**SAN ANTONIO WATER SYSTEM
CENTRAL WATER INTEGRATION PIPELINE
MALTSBERGER PUMP STATION IMPROVEMENTS
SAWS Job No. 18-8617
SAWS Solicitation No. CO-00190**

**ADDENDUM No. 4
August 31, 2018**

SAN ANTONIO WATER SYSTEM
CENTRAL WATER INTEGRATION PIPELINE
MALTSBERGER PS IMPROVEMENTS
PRV III
SINGLE LINE DIAGRAM

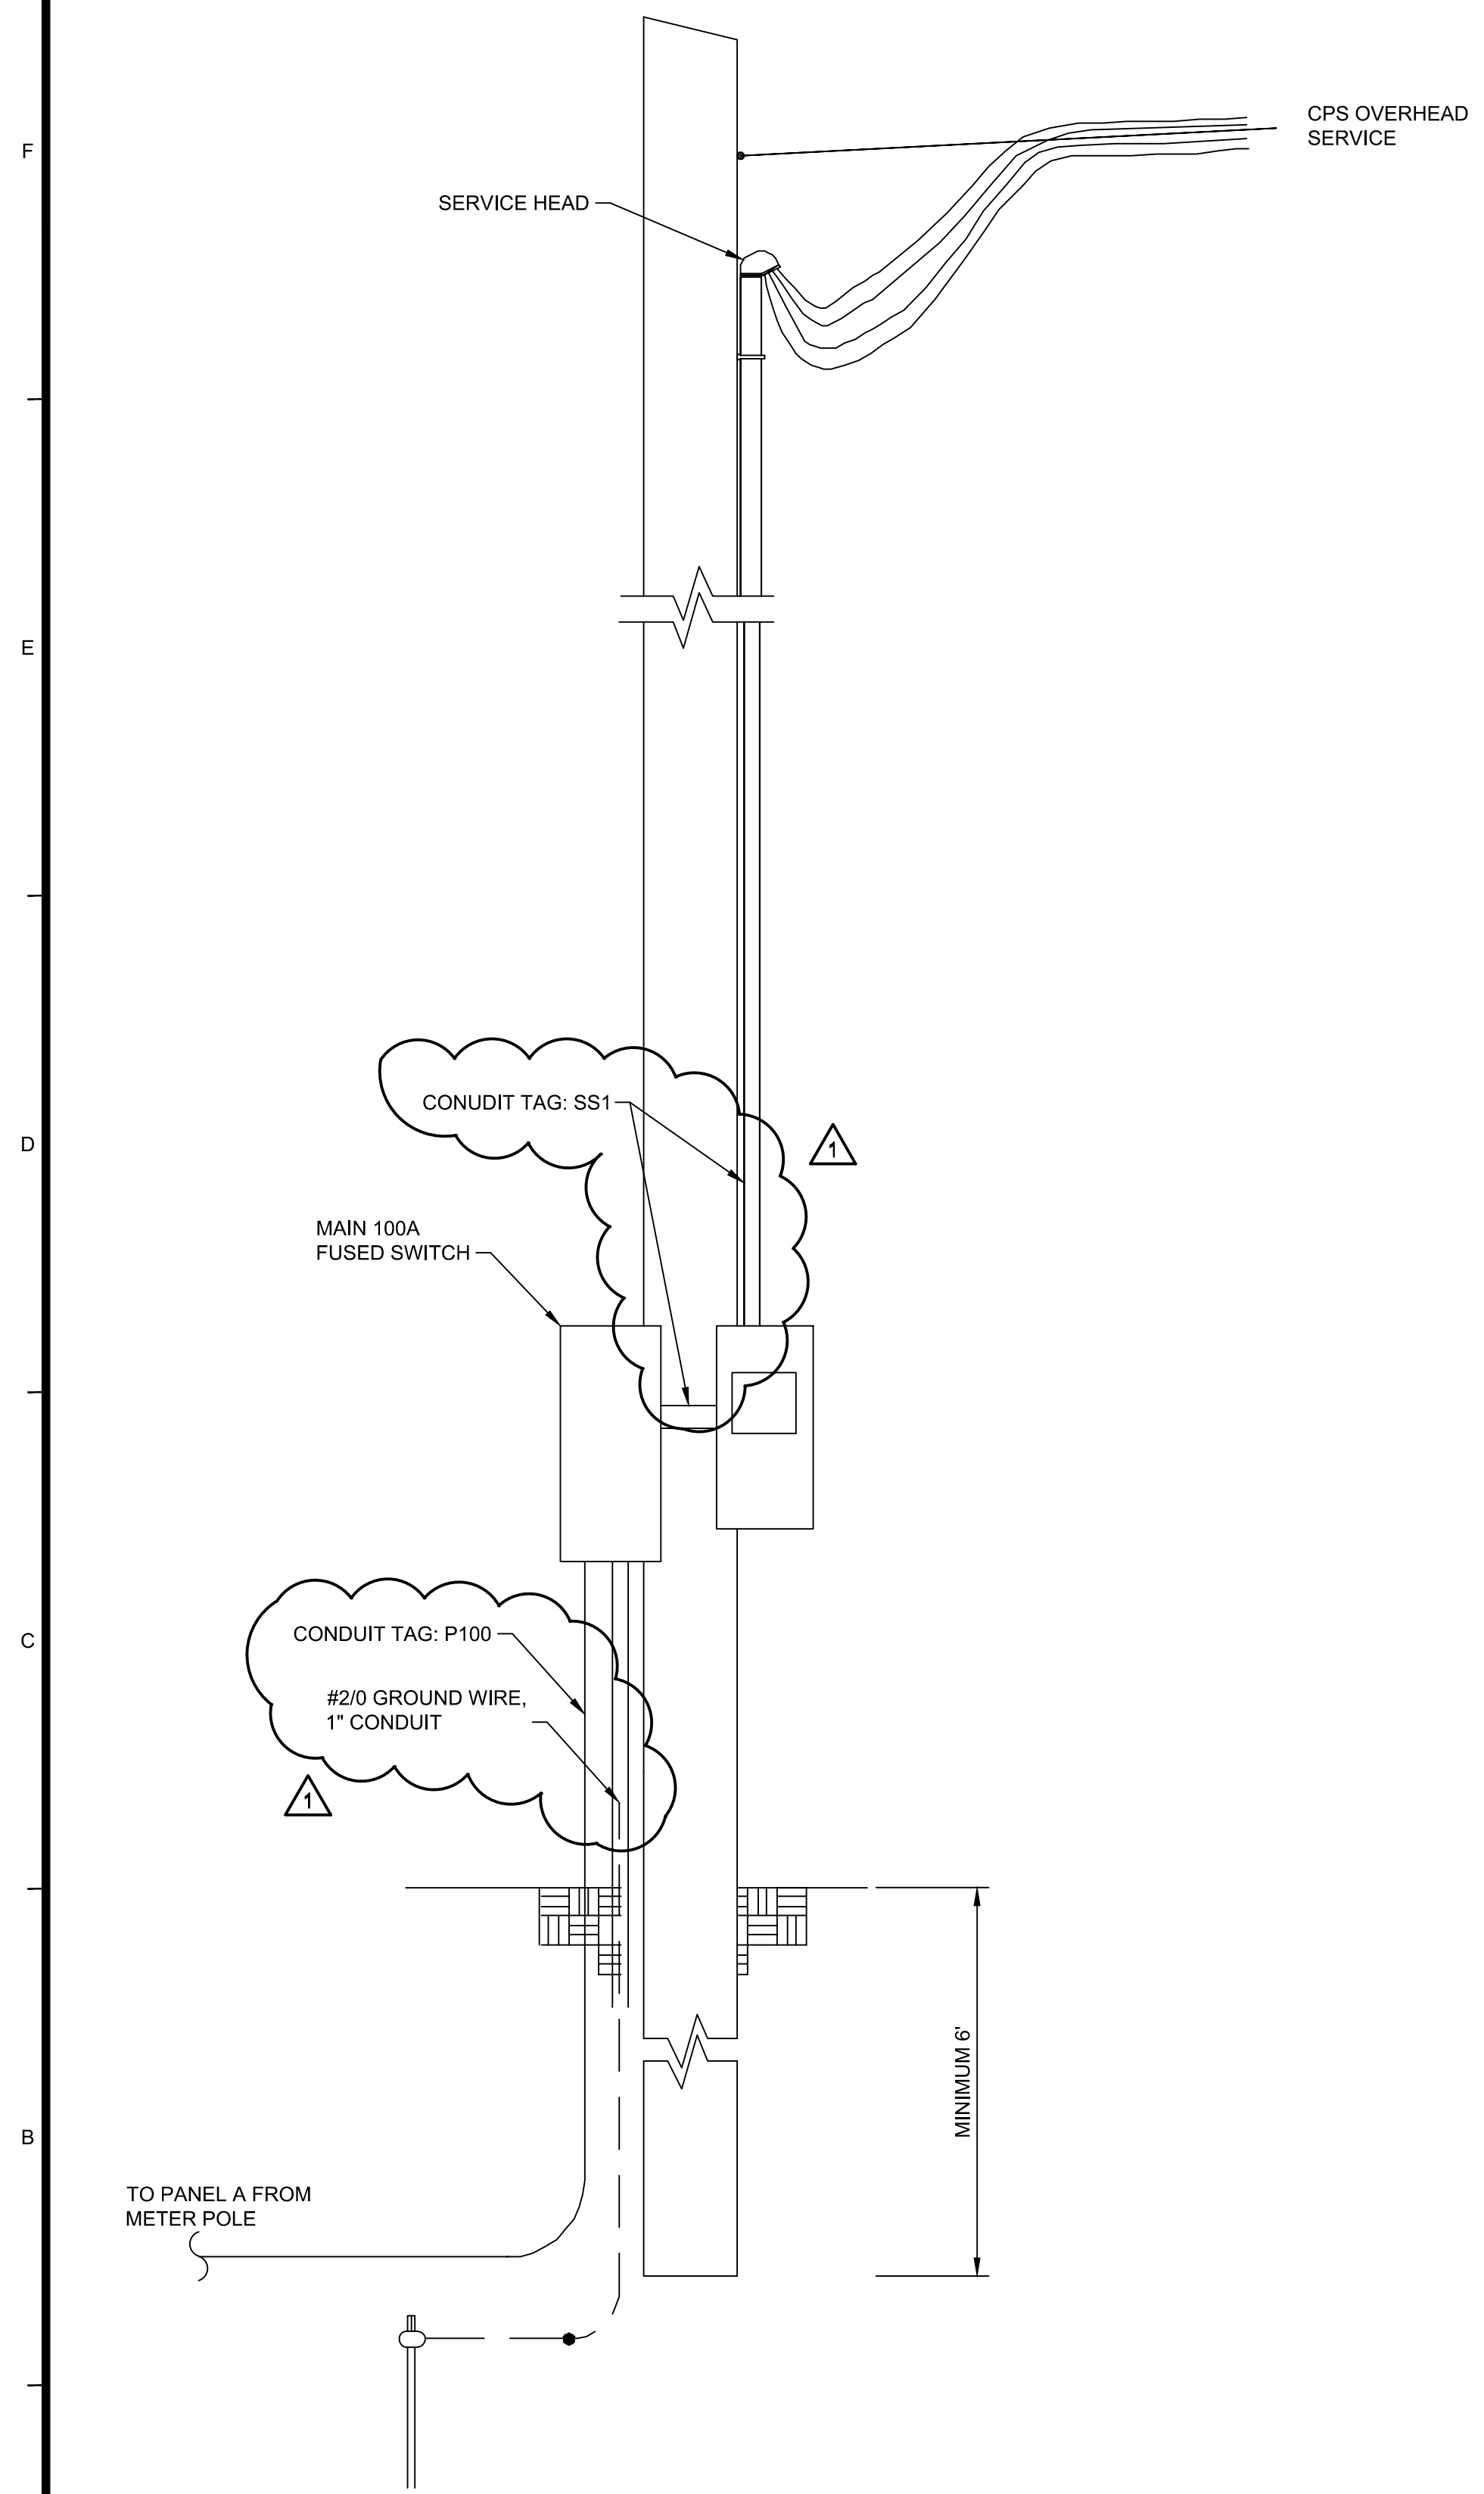
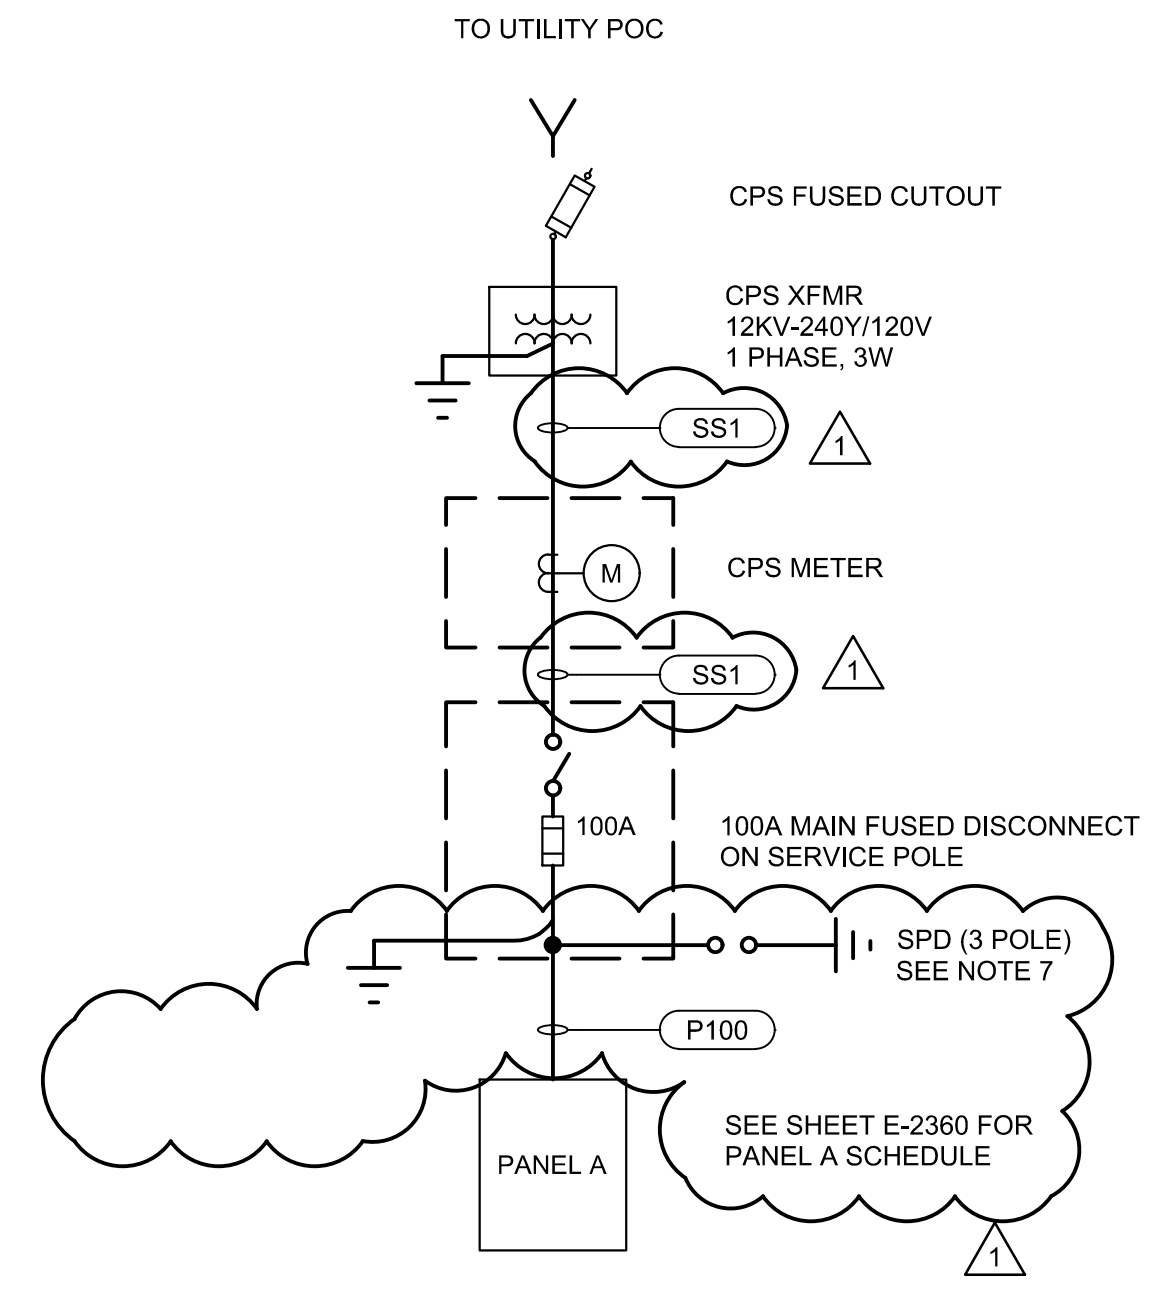
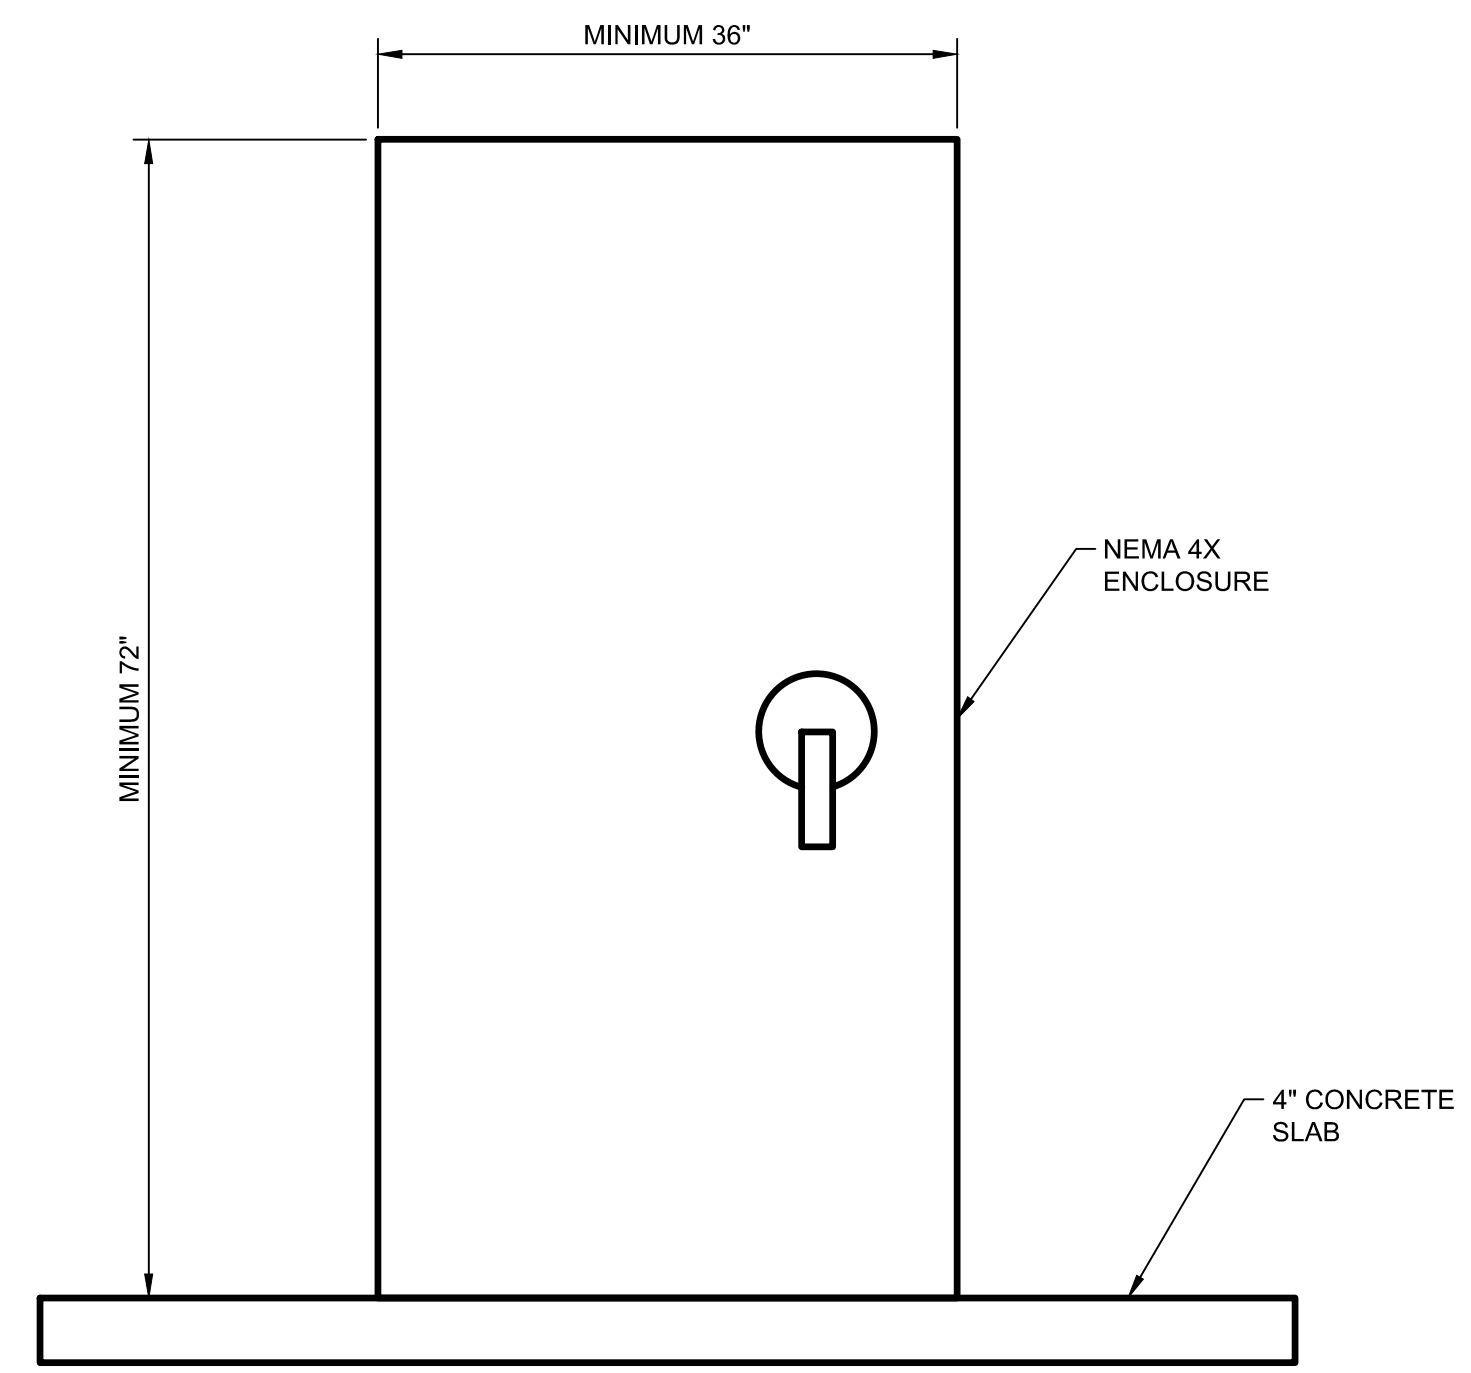
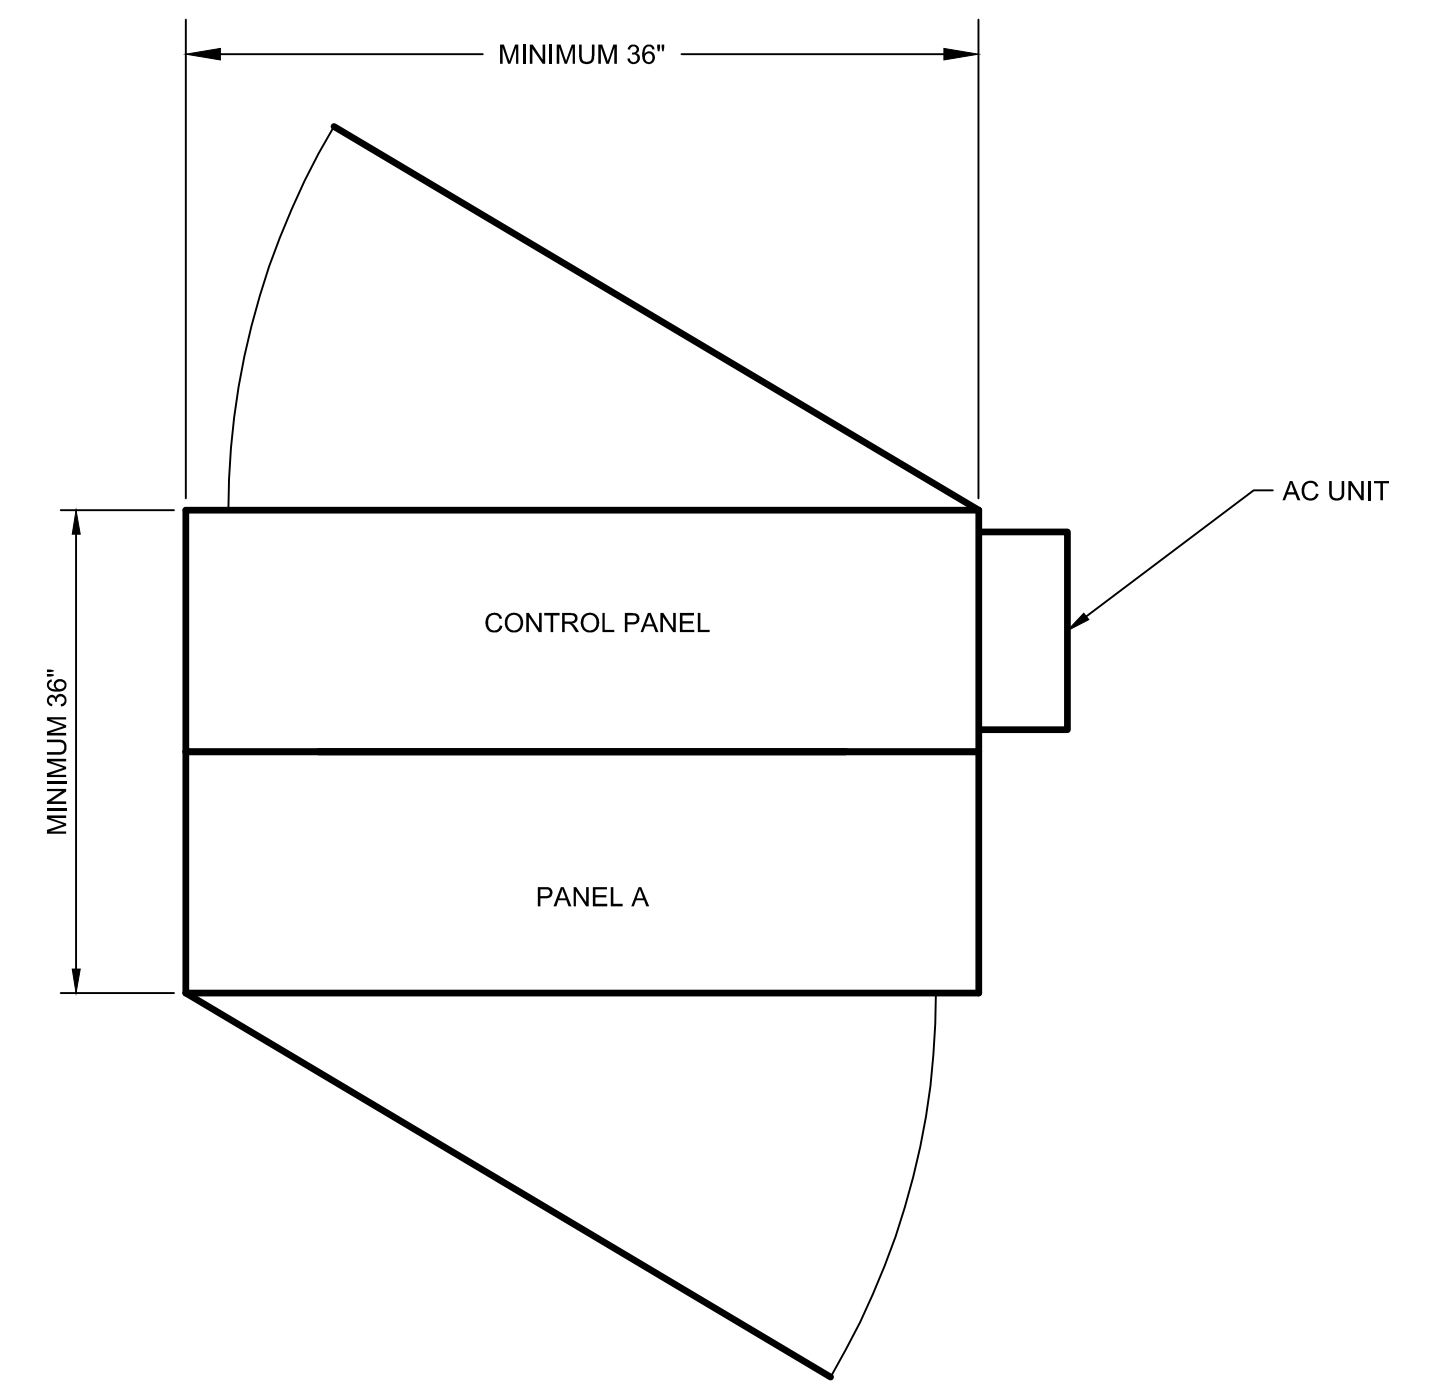
50	Sheet E-2355: Please identify all raceways with conduit tags so we may reference the conduit schedule accurately.	Refer to updated SHEET E-2355 per Addendum No. 4.
51	Sheet E-2356: Please identify equipment and instrumentation and provide a revised conduit schedule that accurately shows the "from-to". Example, conduit "P003" per the conduit schedule goes from "panel A" to "pressure trans panel. "P003" on Sheet E-2353 does not go to a panel, it is shown in the vault.	Conduit schedule has been revised. This is reflected in the changes to SHEET E-2360 per Addendum No. 4.
52	Sheet E-2356: Please provide a conduit schedule showing ALL conduits and their respective source and destination points.	Refer to updated SHEET E-2356 per Addendum No. 4.
53	Sheet E-2360: Please revise conduit schedule and pane "A" schedule so they show ALL conduits and circuits. Refer to previous question for examples. We have not notated all discrepancies due to the amount of discrepancies found. Please revise accordingly.	Refer to updated SHEET E-2360 per Addendum No. 4.
